THE COMMONWEALTH OF MASSACHUSETTS  
WATER RESOURCES COMMISSION

WATER RESOURCES COMMISSION  
DECISION

Town of Mansfield  
Morrison Well #10  
Interbasin Transfer Application

June 8, 2000

TOWN OF MANSFIELD  
PROPOSED MORRISON WELL #10

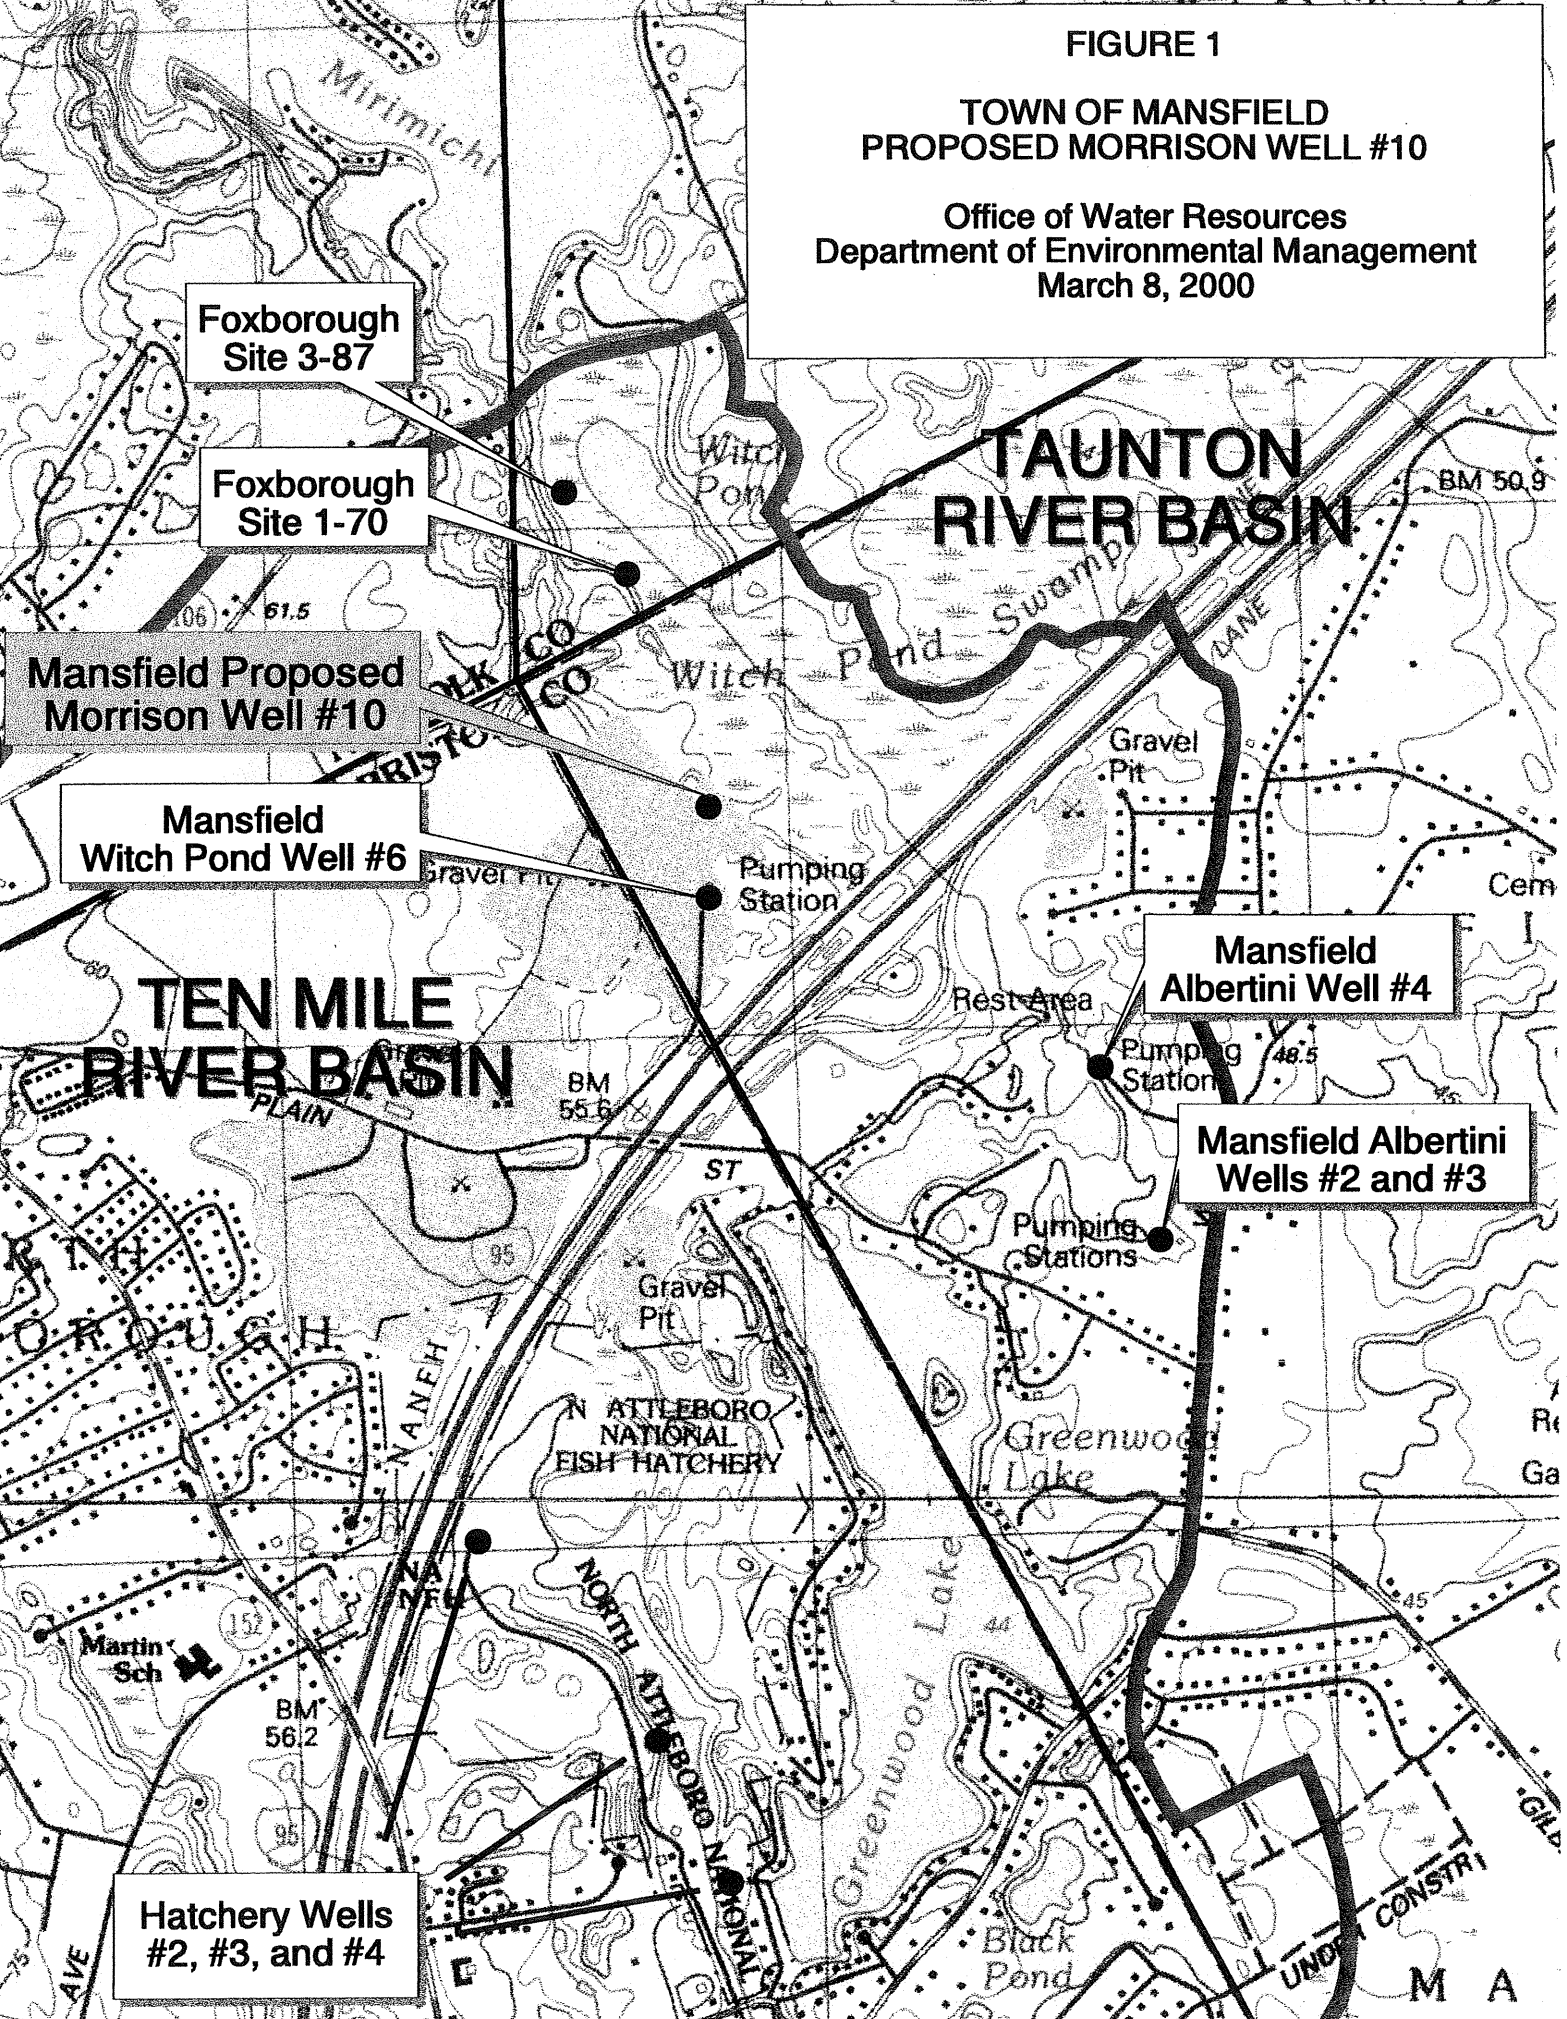
On October 4, 1999, the Massachusetts Water Resources Commission (WRC) received a request for approval of an action to increase the present rate of interbasin transfer under the Interbasin Transfer Act (M.G. L. Chapter 21 §§ 8B-8D) from the Town of Mansfield. Mansfield is proposing to develop a new gravel-packed well in a sand and gravel aquifer near the Witch Pond Swamp in the Bungay Brook subbasin of the Ten Mile River basin (Figure 1).

consistent characterization of the area hydrogeology. The cumulative effects of both well fields were evaluated in the Mansfield IBT application, with a focus on the impacts in closest proximity to the Mansfield wells. Refer to Figure 1 for the Bungay Brook subbasin with the location of Mansfield's existing and proposed wells and Foxborough's proposed wells.

Mansfield's proposed Morrison Well is located in an abandoned gravel pit southwest of the Witch Pond Swamp (Figure 1). Bungay Brook flows from Witch Pond approximately 1,200 feet to the north of the well site, southeastward through the Witch Pond Swamp. The surficial basin divide between the Ten Mile River and Taunton River basins does not function as a ground water divide, as there is indication that ground water flow from Lake Mirimichi in the Taunton River basin provides recharge to Witch Pond (in the Ten Mile River basin) and thereby contributes flow to Bungay Brook.

CROSS SECTION THROUGH TRAVERSE LINE 1  
WHITE CEDAR SWAMP – EXISTING CONDITIONS

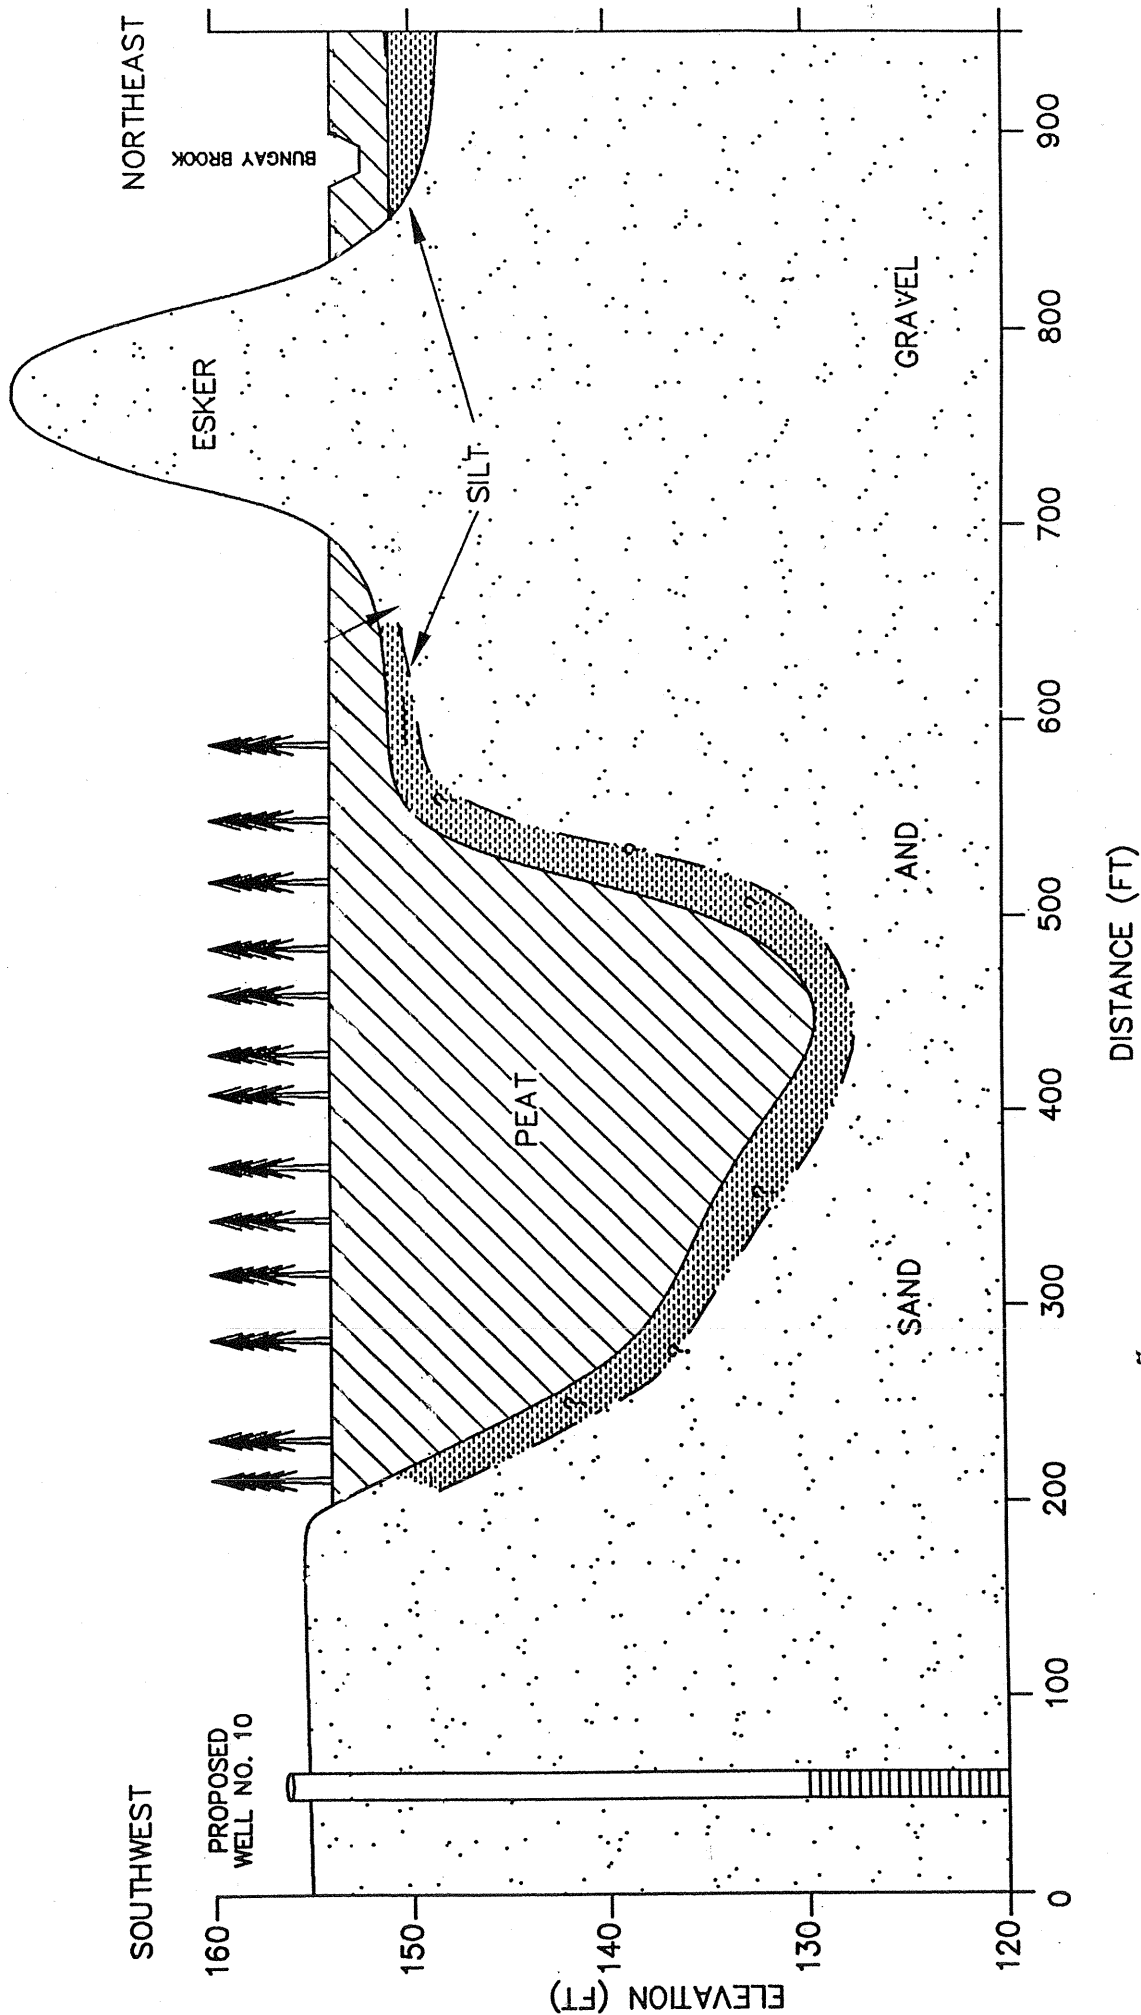
The edge of the gravel formation abuts the Witch Pond Swamp wetlands at a distance of approximately 250 feet from the proposed Morrison Well. At its nearest point, the Bungay Brook channel is located at a distance of approximately 850 feet from the proposed well. Data contained in the pumping test report for Well #10 (Woodard & Curran, 1998) and in the interbasin transfer application for the Morrison Well (1999 and 2000), indicates that Witch Pond Swamp is perched on a peat layer of variable thickness (observed to be up to 26 feet thick in the wetland area east of the proposed well). The base of the peat layer has been observed to be increasingly compact with depth. The peat layer is underlain by a low-permeability silt layer observed at several locations. The area wells are screened in and draw water from a thick sand and gravel formation that surrounds and underlies the swamp. The Morrison Well will be screened at depths of 30 to 40 feet below ground level in the sand and gravel formation. A schematic geological cross section of the proposed well site is depicted in **Figure 2**. An Atlantic white cedar swamp exists within the Witch Pond Swamp wetlands between distances of approximately 300 and 700 feet from the proposed Morrison Well. This swamp serves as a unique habitat for two endangered species: the spotted turtle and Hessel's Hairstreak butterfly. The applicant inspected this area and found that the Atlantic white cedar swamp is in good health and has not suffered detrimental invasion of competing deciduous species (e.g., red maple).

Studies regarding the tolerance of the Atlantic white cedar swamp ecosystem to water level fluctuations (specifically impacts of ground water withdrawals) were not available for use in the review of this application. However, agency personnel and individuals with expertise in Atlantic white cedar in Massachusetts were consulted to ascertain the hydrologic conditions necessary to maintain the Atlantic white cedar swamp ecosystem values and functions. While specific conditions were not identified in these consultations, attributes and characteristics of the ecosystem were identified. To maintain its habitat and to prevent invasion and dominance by other plant species, Atlantic white cedars require periodic inundation and a near-surface water table.
